Access Compliance Report

Public Rights-of-Way

(Pedestrian Signals)

Intersection ID: N/A	Main Street:	Cross Street: N/A	Location: N/A
ADA ID: 6552D16FECC4	Signal Type: One Push Button-Non APS	Overall Compliance: No	Severity Score: BTN 1: N/A BTN 2: N/A No BTN: N/A
Codes/Mitigation Info/Possible Solution		Field Measurements/Component Compliance

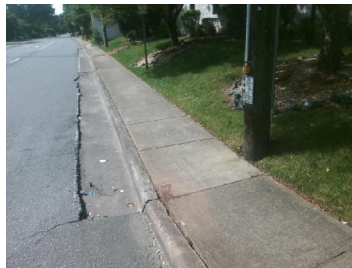
Surveyor Notes: TEXT HT 7/16

PROW/ADA: R410.6, R404.2

Possible Solutions: Remove & Replace Sign.
Remove and Replace Clear Space.
